Responses to SPRIM TAC Evaluation of ArcNLET

The Septic Plume Investigation and Model Refinement (SPIMR) Technical Advisory Committee (TAC) recently reviewed the ArcGIS-based Nitrate Load Estimation Toolkit (ArcNLET) and its applications at Eggleston Height and Julington Creek neighborhoods in Jacksonville. TAC released on 8/10/2012 a review memo summarizing the review process, conclusions, and recommendations. After receiving the memo, the ArcNLET development team at the Florida State University seriously considered the TAC conclusions and recommendations. This file summarizes the responses of the FSU team to the review memo, including clarification on possible misunderstanding of TAC, investigation on problems pointed out by TAC, and future work to address the recommendations. The FSU team appreciates the TAC for their review and recommendations, and look forward to an opportunity of meeting with TAC to discussion the reviews and responses.

Below are the responses of the FSU team to the four TAC recommendations. The recommendation is copied verbatim in Calibri font of size 11; FSU's responses are in Times New Roman font of size 12.

Figure 1. Simulated nitrate plumes and loads to target waterbodies. Loads less than 0.05 kg/d are not shown. The figure is copied from the ArcNLET application manual (Wang et al., 2011).

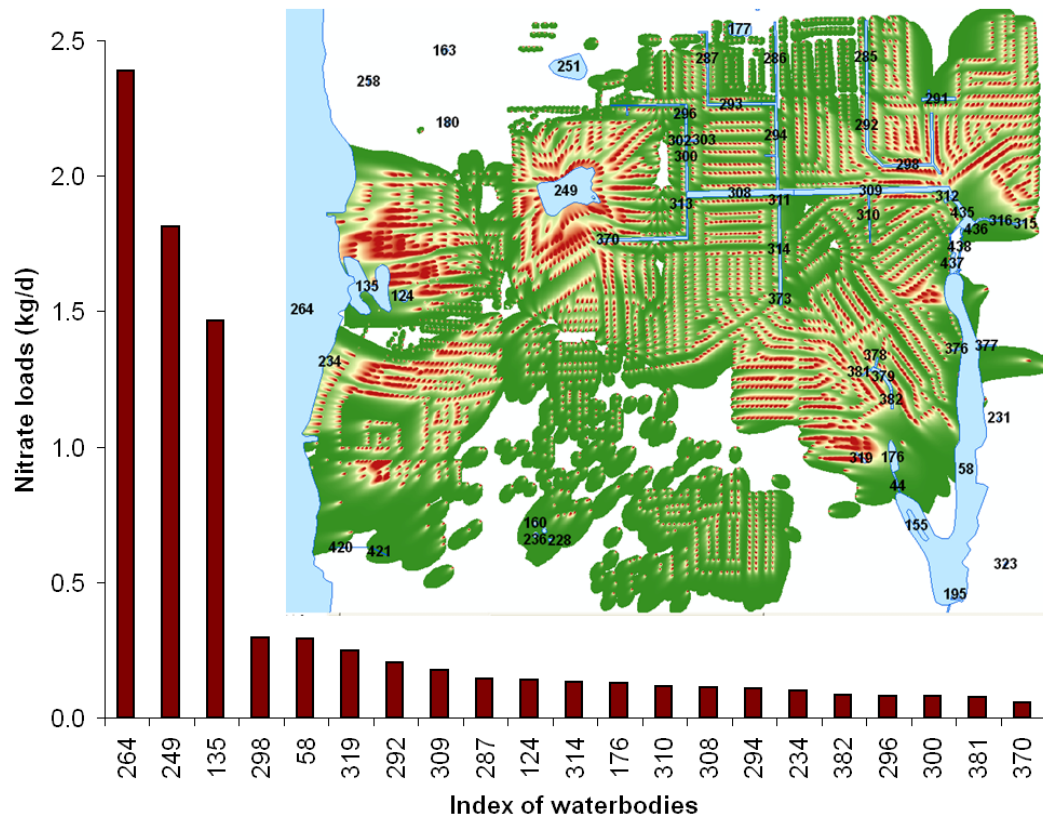
Surface-water drainage network effects on the groundwater gradient and resultant flow path-lines are not fully recognized in the model, presumably due to the gradient smoothing operation. In both the Eggleston and Julington Model, ditches which intersect groundwater were found not to be receiving groundwater discharge.

Clarification: For the problem raised by TAC that “in both the Eggleston and Julington model, ditches which intersect groundwater were found not to be receiving groundwater discharge”, TAC probably misunderstood the modeling results documented in ArcNLET application manual (Wang et al., 2011). Figure 1 for Eggleston Height (Figure 4-6 of the ArcNLET application

manual) shows that ditches do receive groundwater discharge. For example, ditches with indices of 298, 292, 309, 287, 314, 310, 308, 294, 296, 300, and 390 all receives nitrate loads larger than 0.5 kg/day.

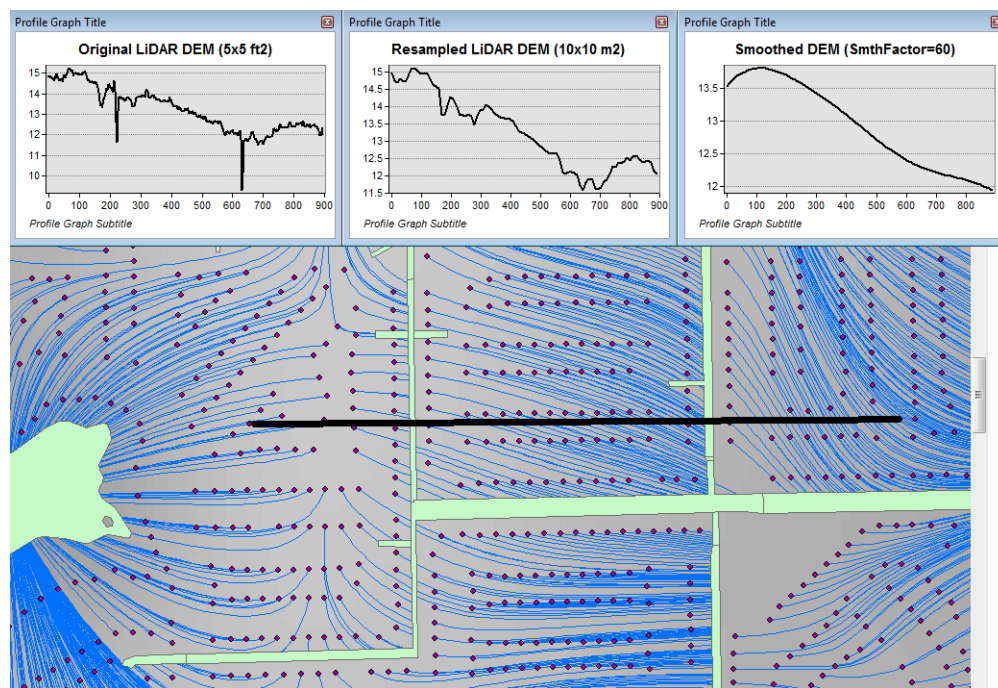
- a. To address the flow path-line issue, ArcNLET algorithms should be adjusted such that resultant flow path-lines conform to expectations that localized groundwater-table depression occurs near wet ditches and the local flow path-lines are generally perpendicular to such ditches. The Eggleston and Julington cases should then be rerun leaving all other parameters unchanged to determine the impact of the flow path-line correction on results. Concurrently, MODFLOW or equivalent hydraulic gradient grids should be prepared and used as input to the fate and transport modules of ArcNLET for both Eggleston and Julington and compared to the flow path corrected result to give an indication of the sensitivity.

Figure 2 illustrates groundwater flow in the current groundwater conceptual model in which the ditches do not control local groundwater flow. The blue lines in the figure represent flow paths from septic tanks (red square) estimated by ArcNLET using smoothing factor of 60. Three profiles of DEM along the black line marked in the figure are plotted; the black line intersects two ditches. Examining the three profiles shows that:

- (1) The profile at the left is based on the original LiDAR DEM with $5 \times 5 \text{ ft}^2$ resolution (provided by Rick Hicks at FDEP), and the two ditches are revealed as the two deep valleys on the profile. It suggests that the LiDAR DEM is able to reflect ditches, including intermittent ditches, at the local scale. The LiDAR DEM is reprojected to NAD_1983_UTM_Zone_17N coordinate system, and the unit of elevation is converted from foot to meter. The raster file used to generate the profile is "duval5_nn_proj_m.img".

- (2) The profile in the middle is for the resampled DEM, from $5 \times 5 \text{ ft}^2$ to $10 \times 10 \text{ m}^2$ resolution, used in the ArcNLET modeling reviewed by TAC. The resampling is to save computational time of ArcNLET modeling, as documented in Section 2.1 of ArcNLET application manual. The profile of the smoothed DEM shows that the resampling resolution is too coarse for the two narrow ditches in that the two ditches are not retained. This problem was reported in the application manual that "the tradeoff between finer resolution and reasonable computational time is determined by users to meet their specific project needs". The solution to this problem is to increase the resampling resolution; in the discussion below, the resolution is empirically increased from $10 \times 10 \text{ m}^2$ to $5 \times 5 \text{ m}^2$.

- (3) The profile at the right is the smoothed DEM obtained after 60 times of smoothing of the resampled DEM. While large-scale spatial variability is preserved, local-scale variability disappears after the smoothing. As a result, for septic systems located down-gradient of (right to) the peak shown in the profile, groundwater from them flow in the down-gradient direction, i.e., to the right. This explains why groundwater flow from certain septic tanks does not flow into nearby ditches. As shown below, smoothing is the dominant reason for the disappearing ditches, even when ditches are retained in the resampled DEM.

Fig. 7 Seasonal variations of shallow groundwater nitrogen species

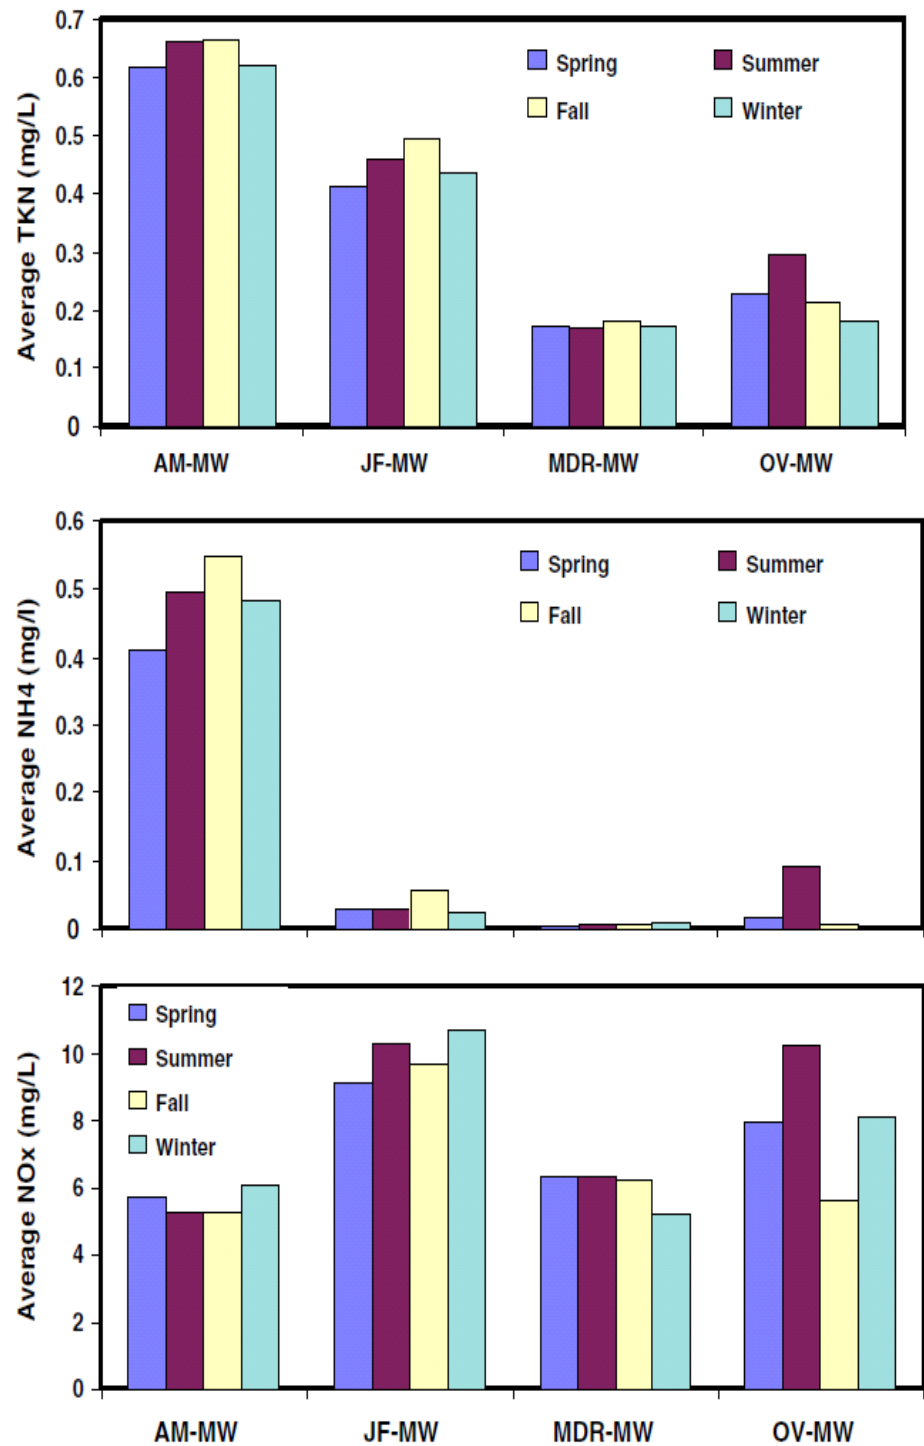
Seasonality as time-varying condition cannot be captured in a steady-state model. A recent study in Jacksonville has found higher nitrate loading in streams during the wet season than in the dry season, and wet season fecal counts twice that of the dry season (Ouyang, 2011). Similarly, intermittent streams and ditches which intercept groundwater flow in the wet season but not in the dry can only be considered as either flowing or dry in a steady state model.

Question to TAC: We have a question regarding the sentence in the TAC report that “A recent study in Jacksonville has found higher nitrate loading in streams during the wet season than in the dry season, and wet season fecal counts twice that of the dry season (Ouyang, 2011).” The study of Ouyang and Zhang (2012) is for groundwater data, but the TAC report indicates that it is for “nitrate loading in stream”. In addition, Ouyang and Zhang (2012) did not report any fecal data collected from Jacksonville. More importantly, their analysis of groundwater data actually suggests that seasonable variation of NO_x concentration (average over individual sites) is relatively small. Their Figure 7, copied below, shows that there is negligible variation in the four seasons in Arlington Manner, Julington Forest Subdivision, Manor Del Rio. It would be useful if the TAC report could elaborate the rational of the TAC’s conclusion regarding the seasonable variation based on the study of Ouyang and Zhang (2012).

These sentences are not a conclusion of Ouyang and Zhang (2012) but an introduction of the work of Arnade (1999) for Palm Bay, not Jacksonville. Regarding nitrate concentration, the data of Arnade (1999) actually showed that nitrate concentration is higher in dry season than in wet season at locations 12-18m distance to septic tank. This is not surprising if we consider transformation of ammonium and nitrate; in dry season, more ammonium can be transformed into nitrate.
